SUBJECT: CERTIFICATION OF THE MINUTES OF THE ACRS APR1400
 SUBCOMMITTEE ON MAY 18, 2017, ROCKVILLE, MARYLAND

SUBJECT: CERTIFIED MINUTES OF THE ACRS APR1400 SUBCOMMITTEE
MEETING ON MAY 18, 2017

**ADVISORY COMMITTEE ON REACTOR SAFEGUARDS
MINUTES OF THE APR1400 SUBCOMMITTEE MEETING ON
MAY 18, 2017, ROCKVILLE, MD**

Chapter 9: Auxiliary Systems

9.2.2 Component Cooling Water System (CCWS)

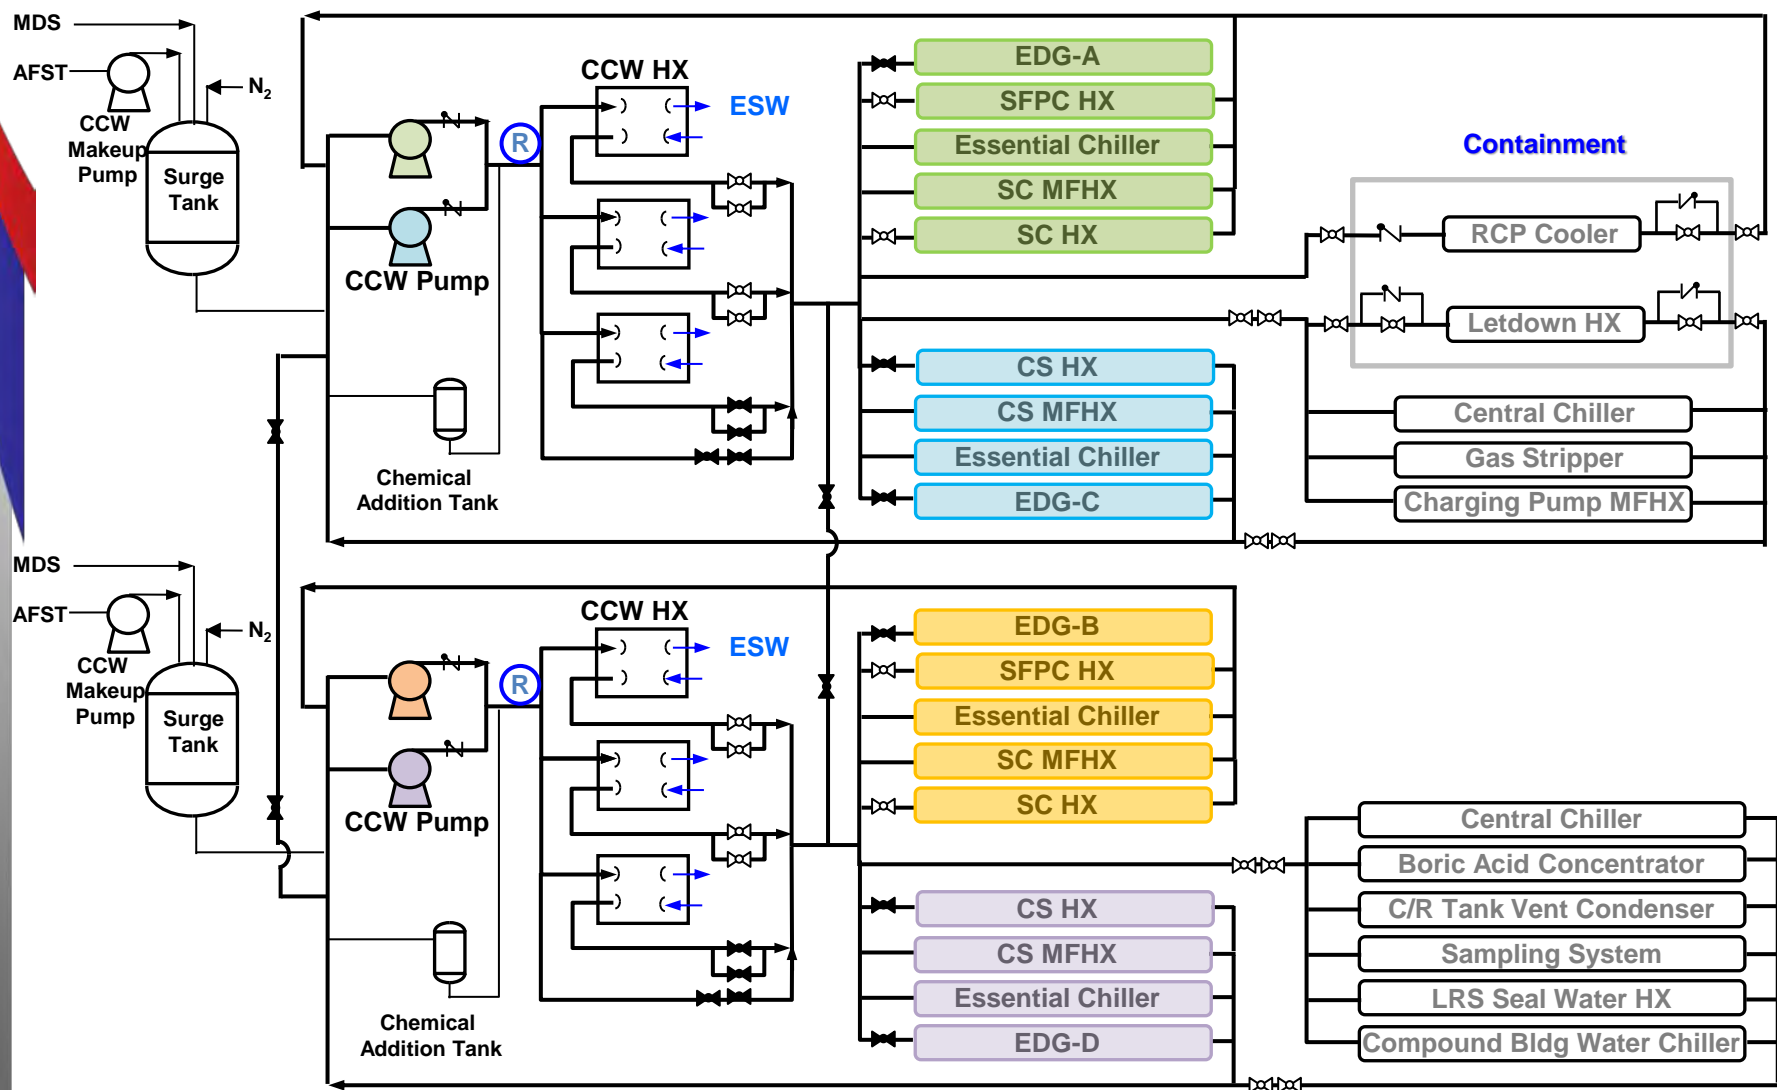
22 MEMBER SUNSERI: I had a question about
23 that. When I look at your detailed drawing -- I know
24 you've got a simplified drawing on the next page -- in
25 the text of the DCD, it describes the flow path for the

5 It has to go up, and then come back down.
6 I'm suspecting that the high point is going to be
7 somewhere near the component water heat exchanger. So
8 it's going to come up to the component heat exchanger.
9 In fact, the drawing says that there's high point vents
10 at the highest elevation, around there. That's the
11 setup for my question. My question is you say your
12 design for water hammer, you've taken the water hammer
13 considerations from the NUREG-0927. I think this
14 design appears to me to be vulnerable to column
15 separation because in the event of a loss of offsite
16 power, the pumps are going to stop. The water on the
17 downstream side of the heat exchanger is going to start
18 draining to the ultimate heat sink.

1 I guess it appears that there's nothing in
2 the design that accounts for that because NUREG-0927
3 talks about keep-full systems and vacuum breakers and
4 such, but I see it looks like this application is
5 passing all of that off to the COL applicant to design
6 the water hammer system. Can you comment on this?

19 MEMBER SUNSERI: I hear you talking about
20 a vacuum breaker. Can you tell me where this vacuum
21 breaker is on this drawing?

24 MEMBER SUNSERI: The detailed drawing is
25 Figure 9.0.1-1 on --

7 MEMBER SUNSERI: Is that the component
8 that's labeled TEWO-052? I don't see a vacuum breaker
9 on this drawing.

21 MEMBER SUNSERI: You might want to look at
22 that section of the DCD and just clarify it. Because
23 it does say that the pump discharges from the discharge
24 continuously upward to the ultimate heat sink, which
25 can't be accurate. Thank you.

22 MR. Y. KIM: This is just the schematic
23 drawing, so I didn't put the details.

3 MR. Y. KIM: DCD Figure 9.2.1-1, there is
4 the systems currently -- the flow diagram. There is
5 a vacuum breaker in each division, downstream of the
6 CCW exchanger.

22 MR. Y. KIM: In the reference plant for the
23 APR1400, we used sea water as the ultimate heat sink.
24 In that case, we made the vacuum breaker downstream of
25 the CCW exchanger. But in the APR1400 design, we have
